**Planning Department  
Transportation Development Services**

**Re: O'Reilly Auto Parts (A15)**  
**12700 Lomas Blvd., NE**  
**Traffic Circulation Layout**  
Engineer's/Architect's Stamp dated 12-14-15 (K22-D019)

Based upon the information provided in your submittal received 12-15-15, the above referenced plan cannot be approved for Building Permit until the following comments are addressed:

## 1 TRAFFIC CIRCULATION LAYOUT PLAN

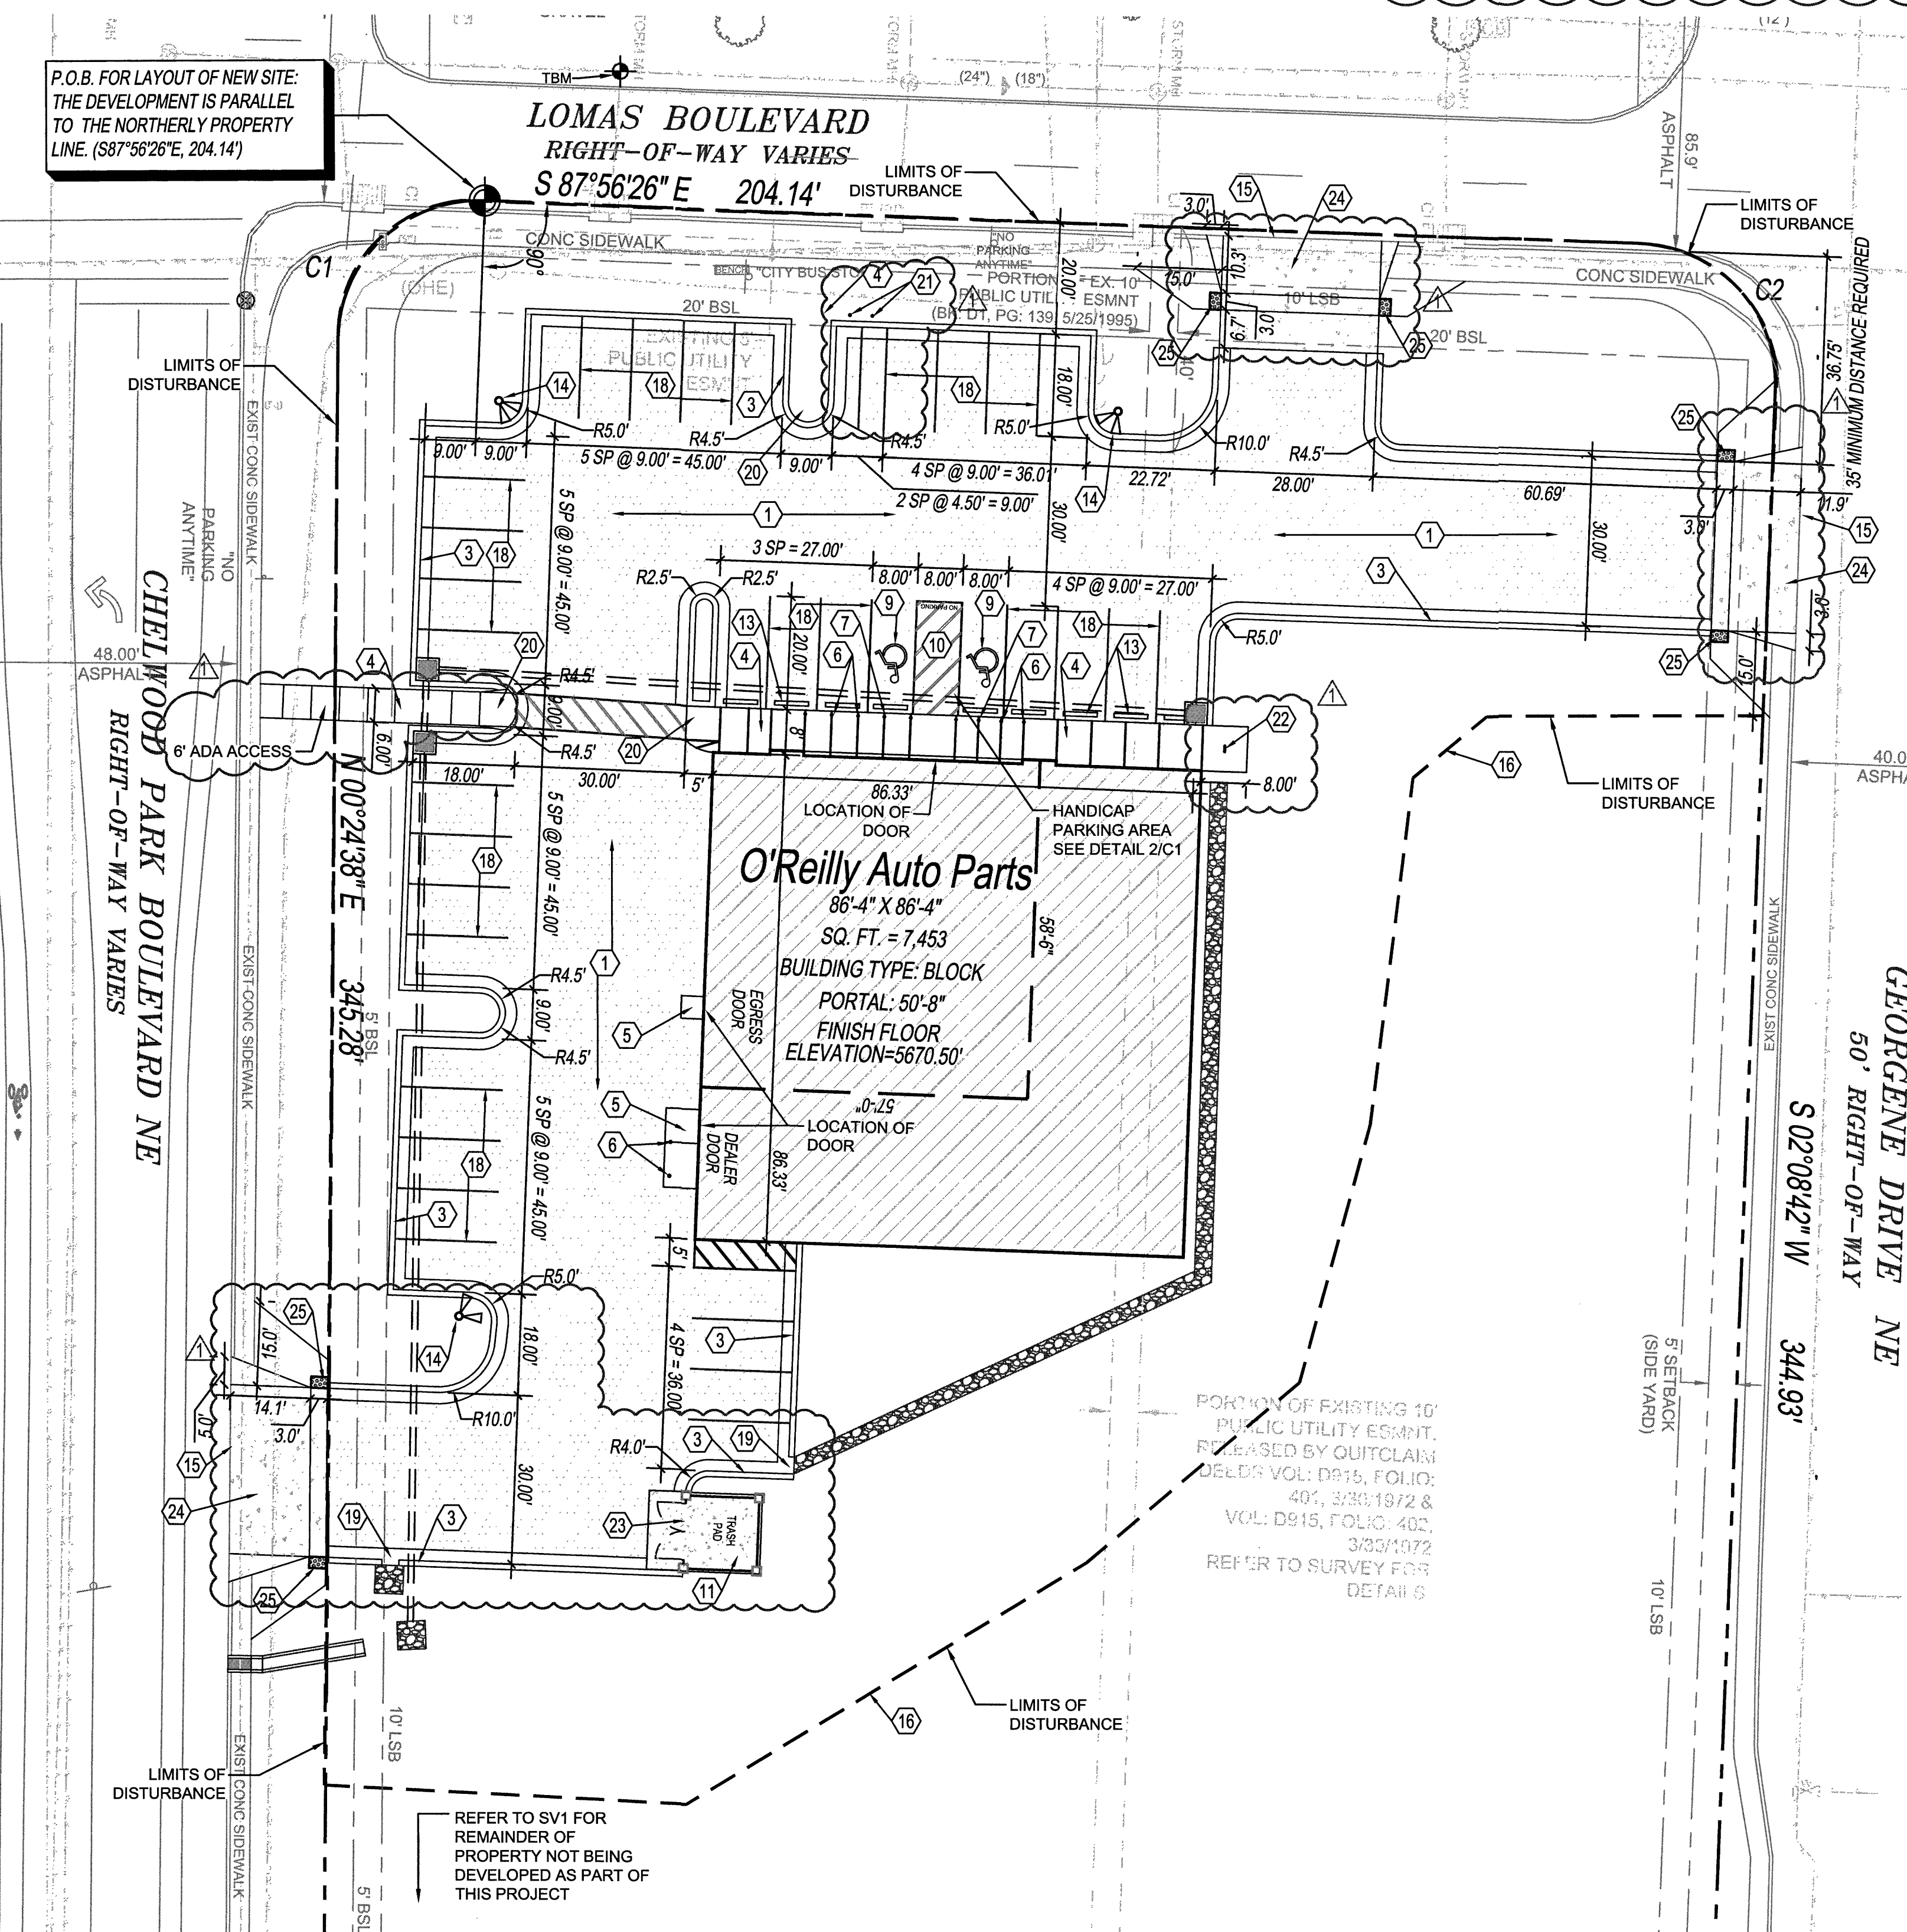
1. The handicap accessible spaces must be a minimum of 8.5 feet in width.
2. Please provide a sight distance exhibit (see the *Development Process Manual, Chapter 23, Section 3, Part D.5 Intersection Sight Distance*). Please show this detail for entrances/exits on Chelwood Park Ave., Lomas Blvd., and Georgene Dr.

3. Please add the following note to the clear sight triangle: "Landscaping and signage will not interfere with clear sight requirements. Therefore, signs, walls, trees, and shrubbery between 3 and 8 feet tall (as measured from the gutter pan) will not be acceptable in this area."

4. All broken or cracked sidewalk must be replaced with sidewalk and curb & gutter. A build note must be provided referring to the appropriate City Standard drawing.
5. Please include two copies of the traffic circulation layout at the next submittal.
